Re: SWAP comments on the draft FFY 2019-2023 Transportation Improvement Program

**PETITION TO LOWER MYSTIC REGIONAL WORKING GROUP &
METROPOLITAN PLANNING ORGANIZATION
October 2017**

Crossing Delay for Each of the 8 Crossings, a.m. peak hour, 5+2-lane Surface Option

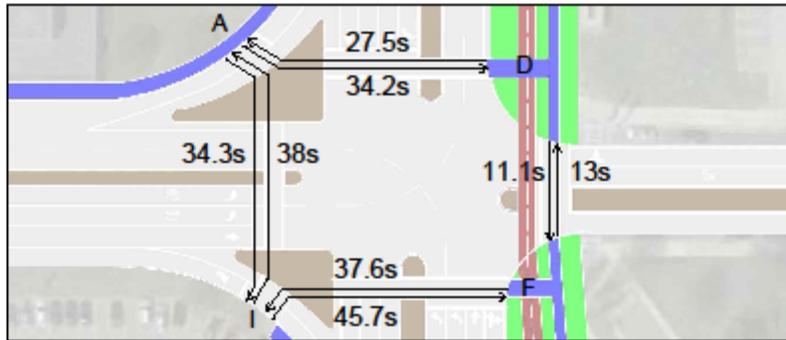
Detailed results on pedestrian crossings are shown in the following figure. Crossing times shown are for full crossings, and include any waiting that pedestrians might have to do at an intermediate island.

Calculating crossing delay is not a routine task in the industry. An appendix to this report shows the timing for all of the pedestrian phases in the a.m., and sample output from the program used to determine average pedestrian delay was calculated. The Synchro report showing vehicular performance measures is also provided in an appendix.

For Pedestrians: Crossings with Unacceptable Right-Turn Conflicts

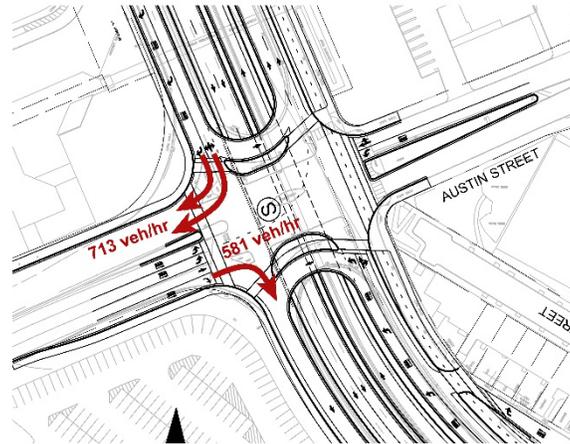
- Three of its four pedestrian crossings are unsafe – that is, they involve conflicts with right turning traffic with traffic volumes nearly triple the limit allowed by MassDOT.
- While cars that can use the underpass will fly through unimpeded, the surface streets will face delays of 2 to 2.5 minutes, with queues on the Rutherford Ave surface roads growing to almost 500 ft in both directions.
- Far from protecting the neighborhood from cut-through traffic, the underpass option will actually create serious congestion that gives traffic heading to the Gilmore Bridge an incentive to cut through the neighborhood.

The layout of the underpass option (see figure below) looks pedestrian-friendly – there are crosswalks across all four legs of the intersection, there are no delta islands with slip lanes for right turning traffic, and the Austin Street crosswalks are drawn in a way that shows that pedestrians there will have simple, one-stage crossings.

Vehicular delay for the two options

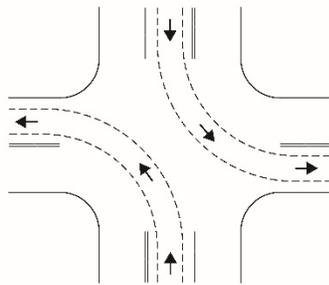
underpass option	7-lane surface option
Thru traffic on Rutherford Ave		
- Southbound thru average delay (s)	0	43
- Northbound thru average delay (s)	0	24
All other movements		
- Average delay (s)	74	59
- Average delay for most congested movement (s)	152	87
Average delay, all traffic (s)	40	48

The underpass option removes 40 percent of the traffic from the intersection, yet it performs poorly compared to a surface option. How can this be? It turns out that there are three aspects of an underpass that makes it an inherently inefficient solution.

Lefts at compact intersections do not conflict.

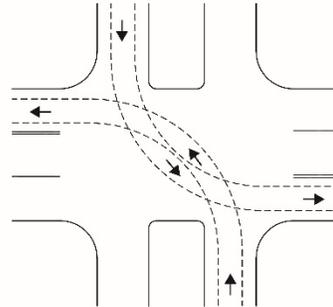
Second, ***an underpass creates a split intersection.*** The northbound and southbound surface roads will be separated from one another by about 60 ft. As a result, left turns cannot run concurrently, because they interlock, as illustrated in the figure below. The traffic signal plan is therefore forced to follow an arrangement called “split phasing,” in which each of the four legs has a turn in sequence. Split phasing is both less flexible and less efficient than the normal phase sequence in which opposite directions (e.g., northbound and southbound) run concurrently. One can observe this inefficiency at other intersections with underpasses, such as Mass Ave @ Commonwealth Ave and Mass Ave @ Huntington Ave in Boston, where traffic on the surface roads is often backed up.

Interlocking lefts at split intersections cannot run concurrently.

Split intersections result in interlocking lefts, which prevent left turns from running concurrently

City Square to Austin Street – Underpass Option

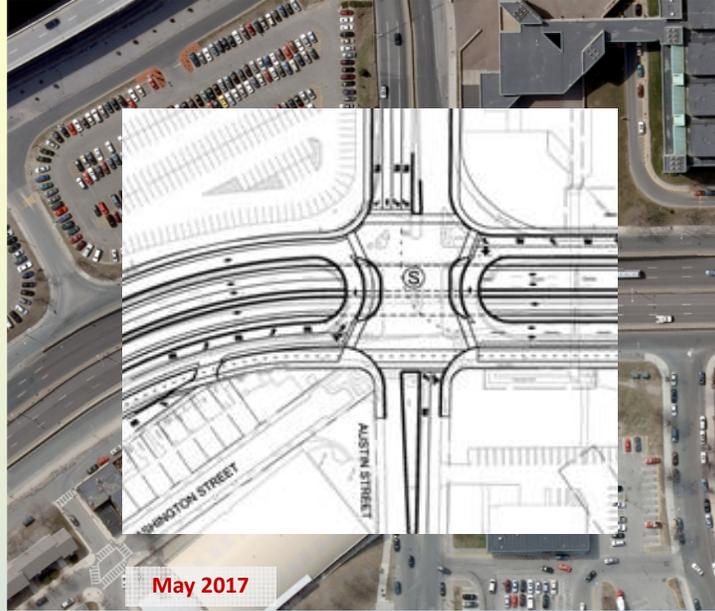
- 18' wide at narrowest point
- 24' wide for most of the area
- 24' wide at Austin Street

Essex to Mishawum Street – Underpass Option

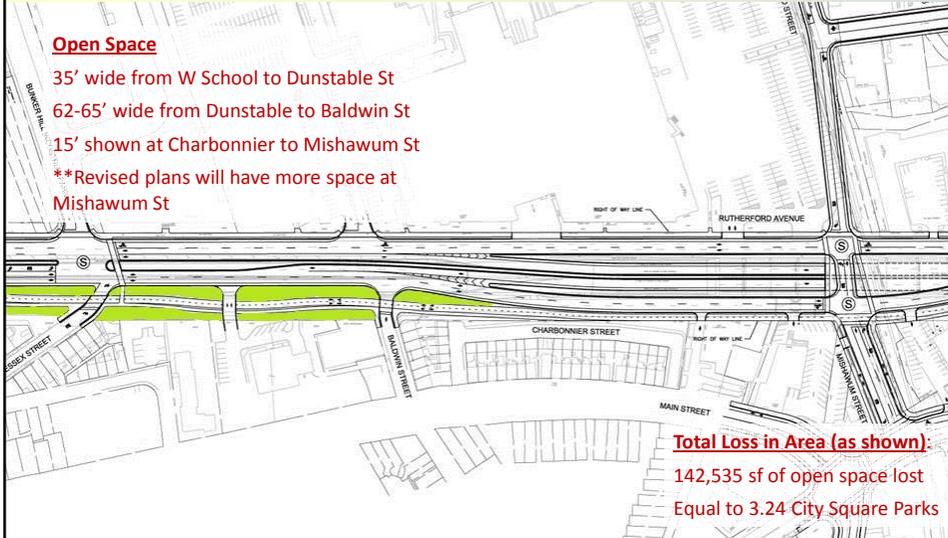
- 35' wide from W School to Dunstable St
- 62-65' wide from Dunstable to Baldwin St
- 15' shown at Charbonnier to Mishawum St
- **Revised plans will have more space at Mishawum St

Total Loss in Area (as shown):
142,535 sf of open space lost
Equal to 3.24 City Square Parks

Rutherford Ave. Cross Section: Existing at Mishawum St.

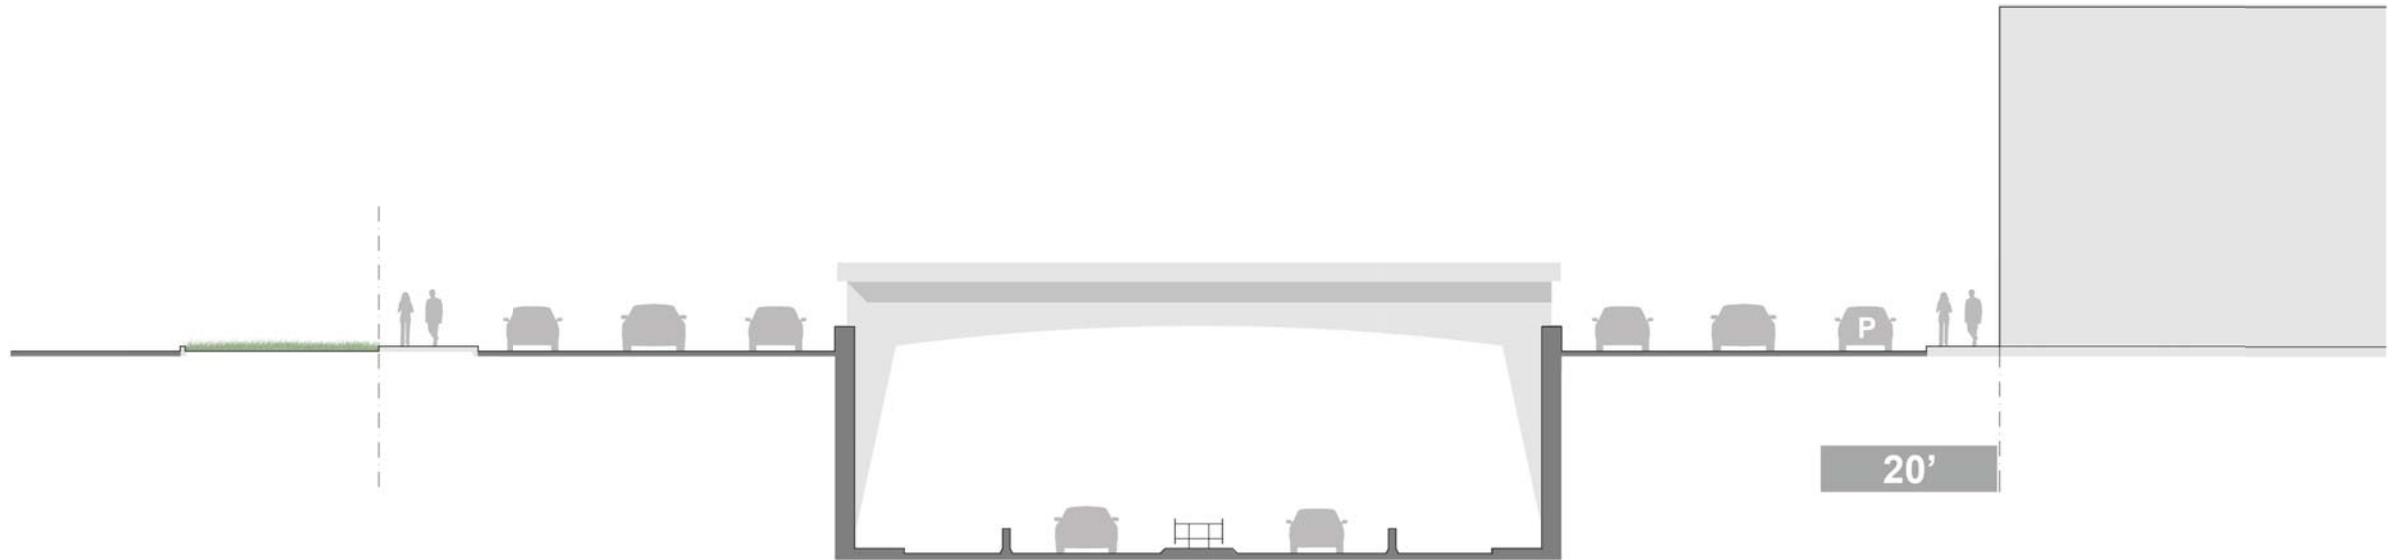
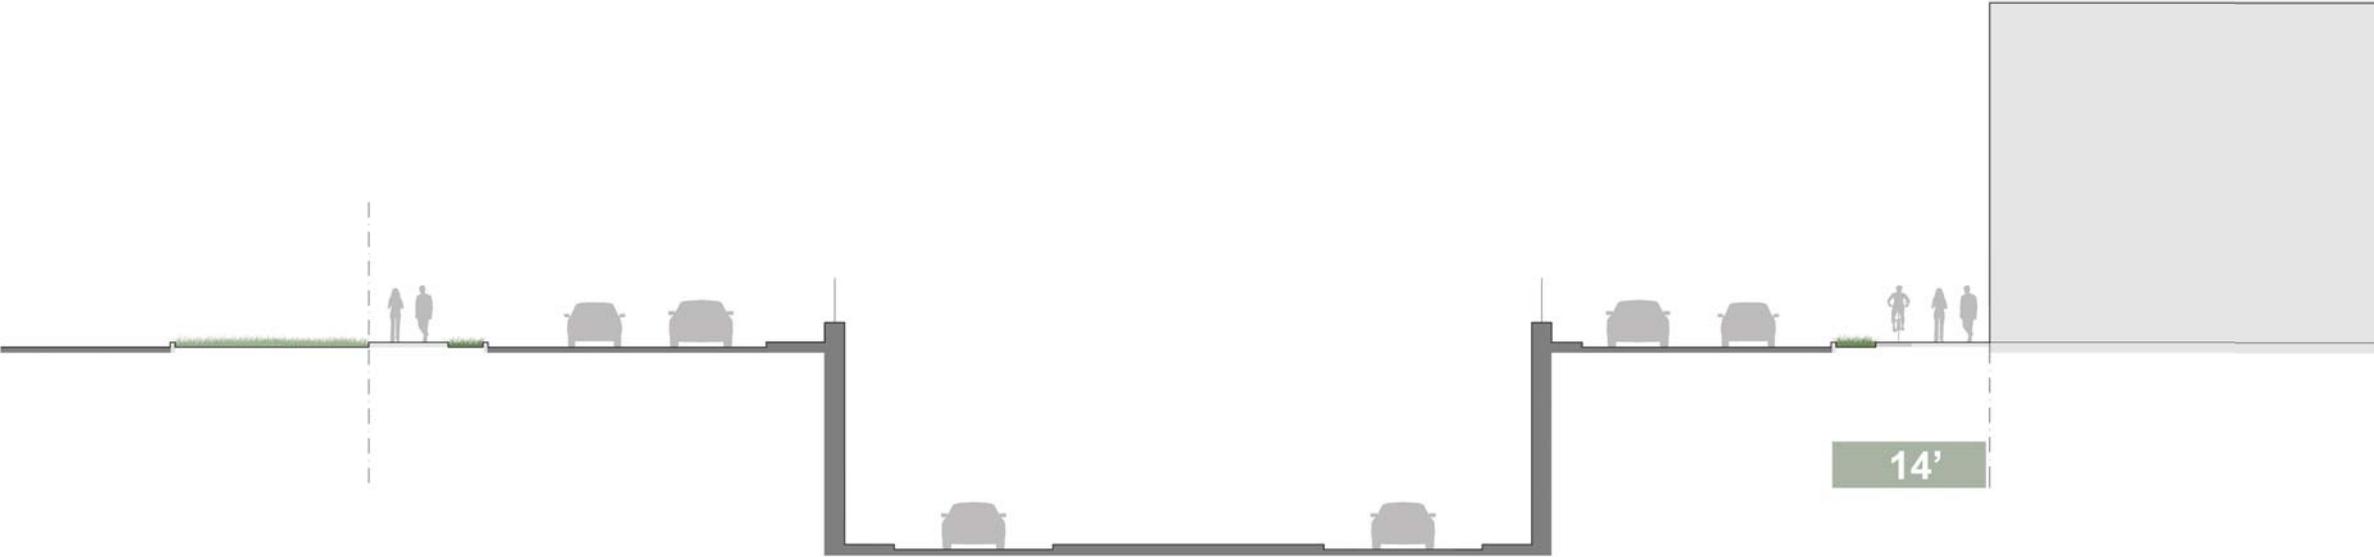
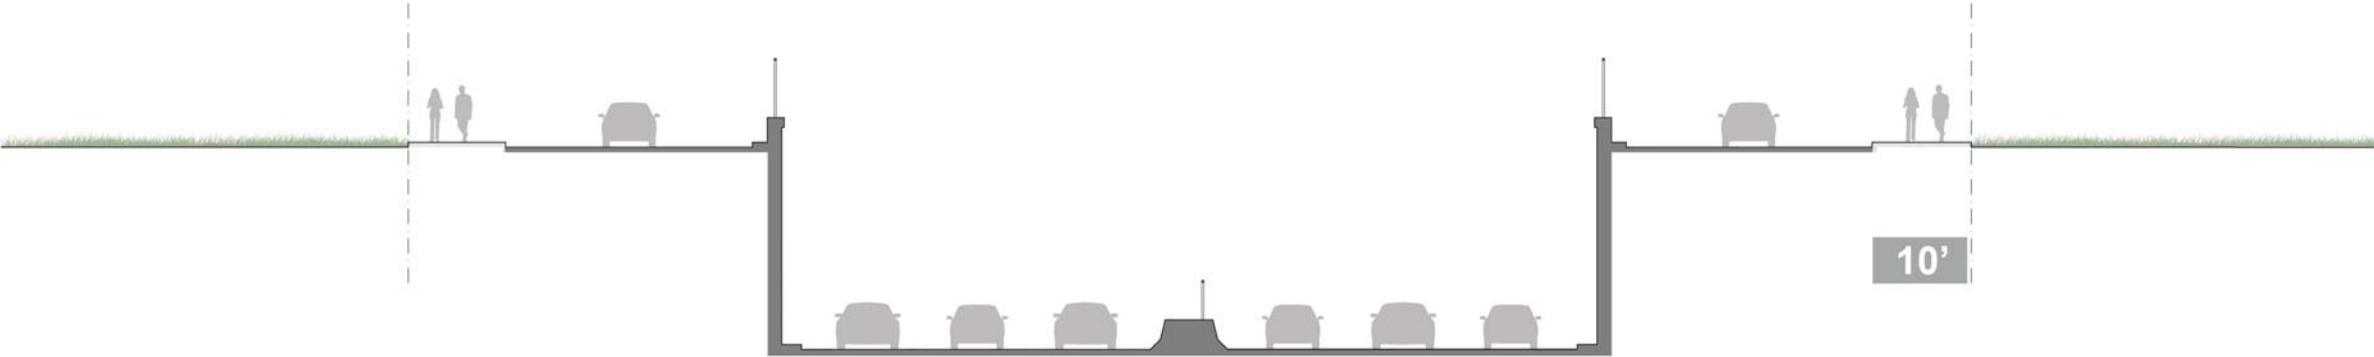
50'+/- Neighborhood Buffer

Rutherford Ave. Cross Section:
Existing at Austin St.

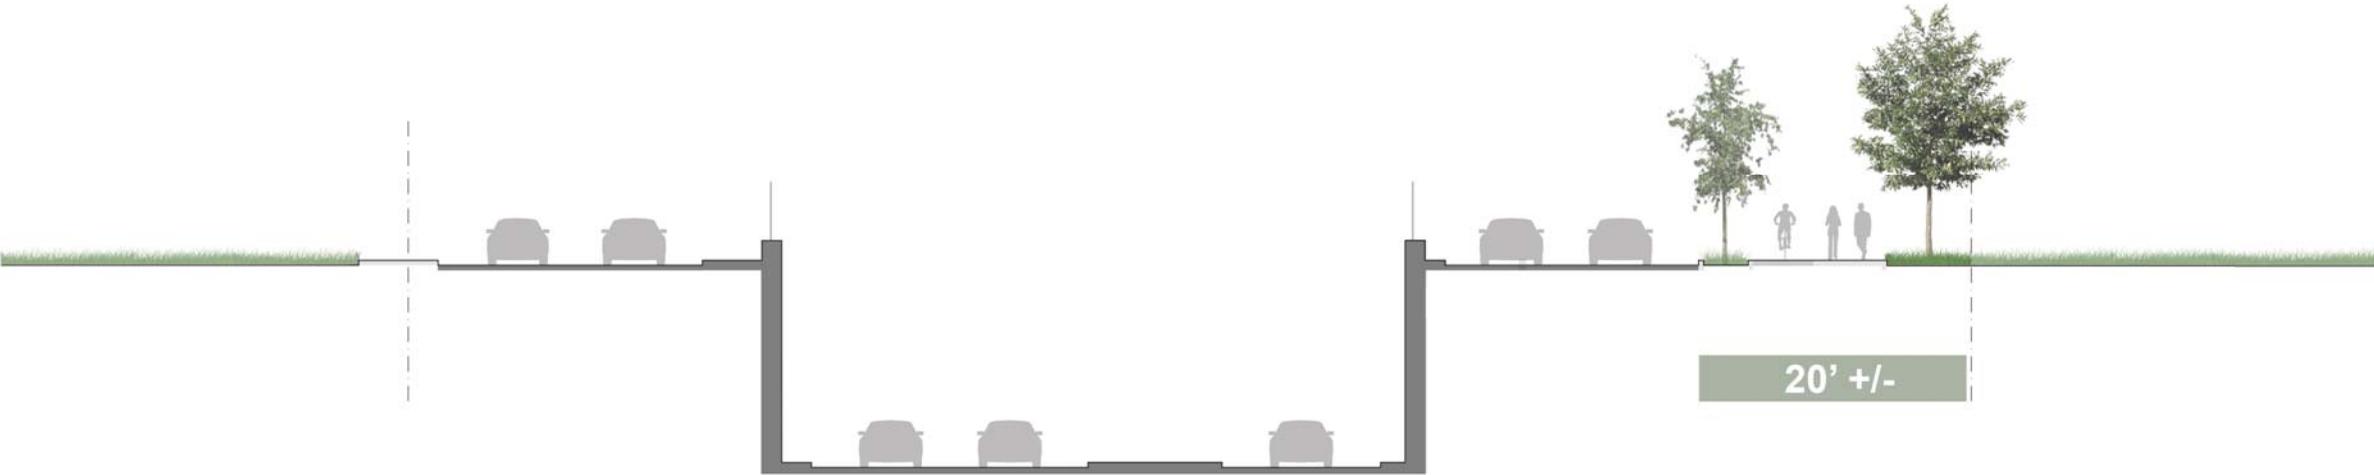
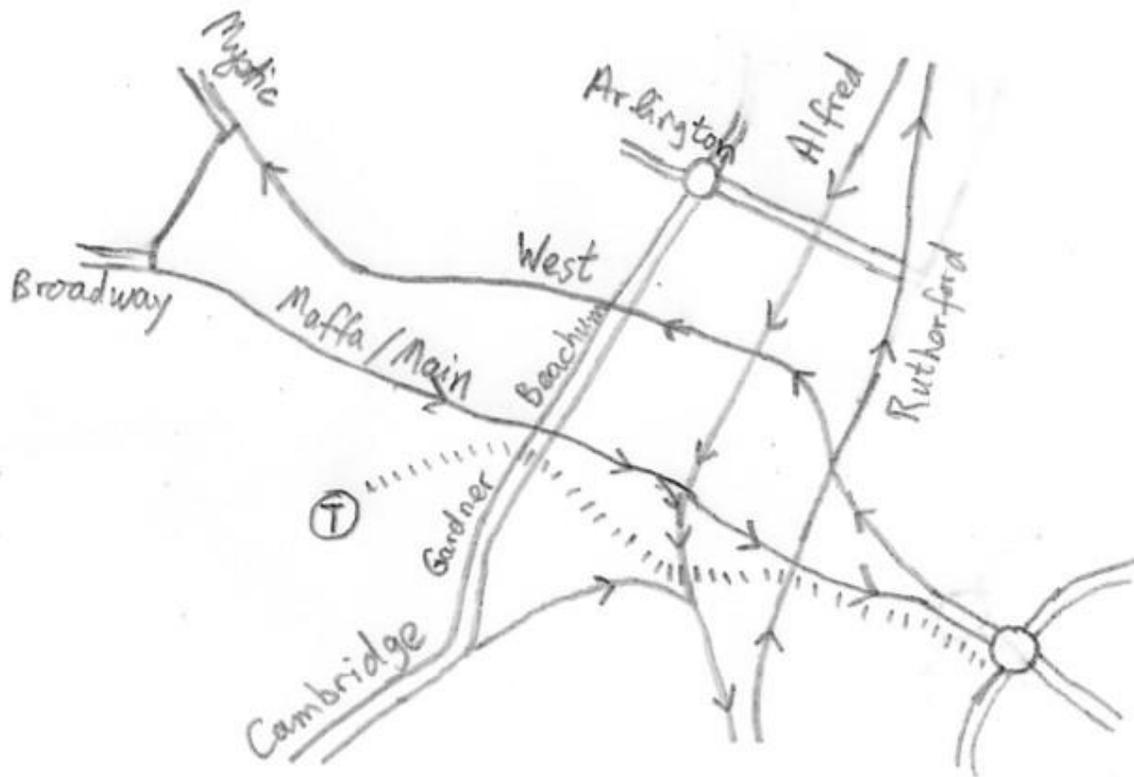
+50' Linear Park

+50' Linear Park
